- Statement of Direction (SOD) for Major
 Special Use Permit (SUP) amendment for
 Lincoln Medical Plaza at 7125 E Lincoln Drive
 - SOD Action (Tentative) June 14th
- Points to keep in mind
 - Several aspects of project do not meet SUP Guidelines and/or may be in conflict with General Plan policies
 - Height, traffic and circulation, and depth of the perimeter landscape buffers are of particular concern
 - Many application submittal items are not fully complete, but do provide the nature of the proposed redevelopment

COMPONENTS - PROPOSED MAJOR SUP AMENDMENT

SITE PLAN

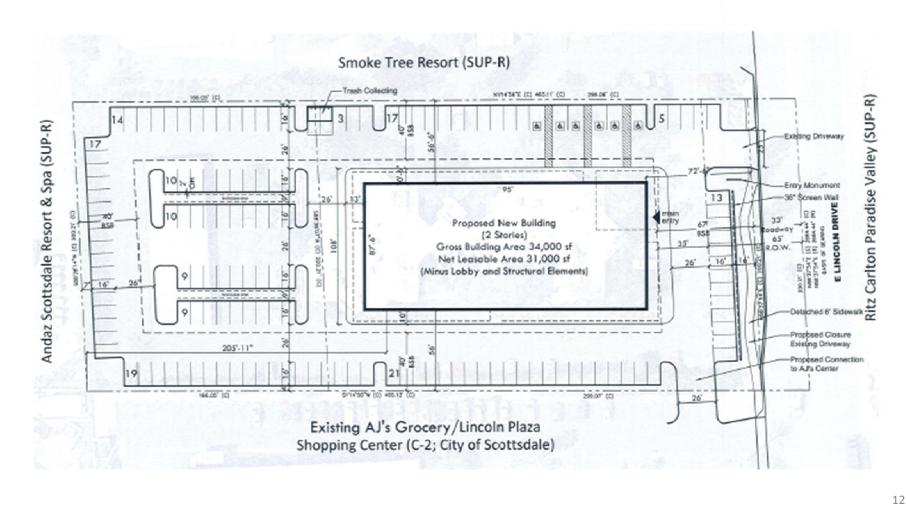
New, single-tenant medical office building

■ Two-story, 36' high structure

147 Parking spaces (some may be covered)

SOD CONSIDERATION POINTS — HEIGHT

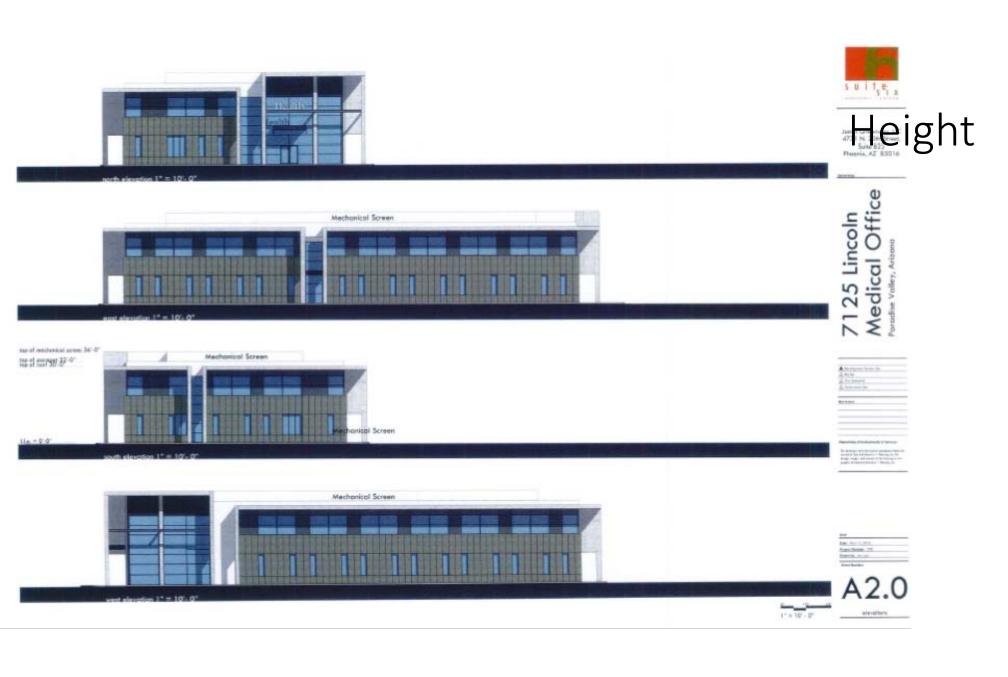
Торіс	Town Code/Special Use Permit Guideline/Town Policy Existing Condition	Proposal by Applicant Suggested SOD Focus
Height	The Special Use Permit Guidelines for medical office suggest a maximum height of 30'0" for principal structures, with possible consideration for higher	Plans show a maximum height of 36'0" to the top of the mechanical screening, 30'0" height to the top of the roof, and height measured from the finished floor elevation versus natural grade.
	height to accommodate architectural features SOD to address heights (SUP Section 1102.3.B.4 Zoning Ordinance) Existing heights 24'0", with some portion to	Suggested SOD Language It is recommended that the Planning Commission evaluate the proposed height as to its impact to adjacent properties and the operational needs for medical office use; minimizing height where possible through means such as articulation of the roofline, reducing the area of the roof mechanical equipment screening, and reduction of the overall height. A compelling reason must be given for height proposed over 30'.

mechanical screening at 27'0"	Finished floor is not an appropriate measurement point. It is recommended that all heights be taken from finished grade and that finished grade cannot be raised more than two feet above existing grade. Fill shall (or shall not) be counted in height measurement. If any portion of the rooftop is visible off-site, care should be taken to minimize the impact. White roofing material is discouraged if visible off-site.

SOD CONSIDERATION POINTS — SETBACKS

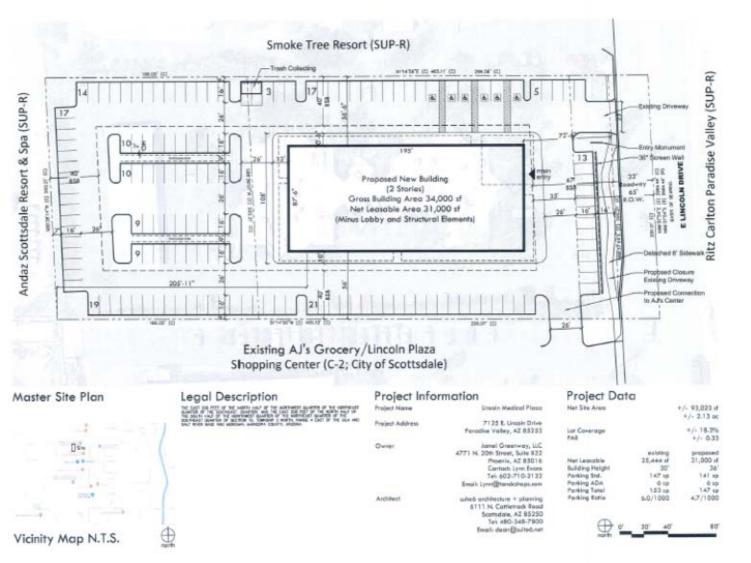
Торіс	Town Code/Special Use Permit Guideline/Town Policy Existing Condition	Proposal by Applicant Suggested SOD Focus
Setbacks	This site is unique in that the adjoining properties are all non-residential. As such, the only Special Use Permit Guideline that applies on setback is the suggested 40' setback from a public street.	The proposed setbacks of 67' front yard (35' with full right-of-way dedication), 56' side yards, and 185' rear yard is consistent with Town Special Use Permit Guidelines
	The existing structure is setback 94' from Lincoln Dr (62' with full right-of-way dedication).	Applicant will need to provide plans for the proposed covered parking.
	The existing covered parking is south of the existing building, setback well beyond 40' from	Suggested SOD Language
	Lincoln Dr.	Setbacks meet SUP Guidelines but may need to be increased along Lincoln Drive to accommodate the recommended 50-foot wide landscape buffer adjoining a major arterial. If covered parking is provided, setbacks from these structures will also need to be reviewed.

SOD CONSIDERATION POINTS — LANDSCAPE/BUFFERING

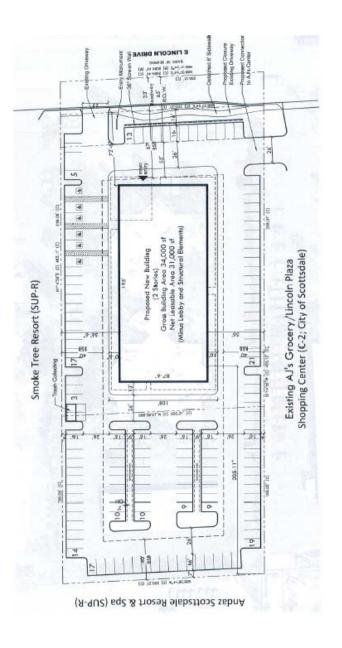
Торіс	Town Code/Special Use Permit Guideline/Town Policy Existing Condition	Proposal by Applicant Suggested SOD Focus
Landscape/ Buffering	50' buffer along major roads (SUP	16' and 30' along Lincoln Dr
	Guideline)	(includes portion of future right-of-way)
		4' buffer on sides and 7' buffer in rear
	General Plan Policy EP 6.1.1.3 Mature	
	Landscape Preservation. The Town	Based on the proposed building design,
	shall require new development and	the large trees in the center of the site
	redevelopment to preserve mature	will be removed
	indigenous and compatible landscaping	
	on-site where feasible. Several large	Suggested SOD Language
	trees on the site.	Particular attention shall be paid to the buffer along
		Lincoln Drive based on the proposed Visually
	Existing buffers	Significant Corridor study and the improvements
	34' Lincoln Dr (16' in existing ROW)	proposed at the Ritz property just to the north. A

3'6" sides and rear yard	stipulation may be considered to ensure
	Existing tall hedges and 3' to 6' tall	replacement of any buffer should the landscaping
	block wall act as perimeter buffers	die. A landscape plan shall be required. The
		Commission shall evaluate the proper balance of
		landscaping to soften the building while not
		obscuring it from the street. Hardscaping and
		pedestrian access shall be considered with the
		landscape plan.
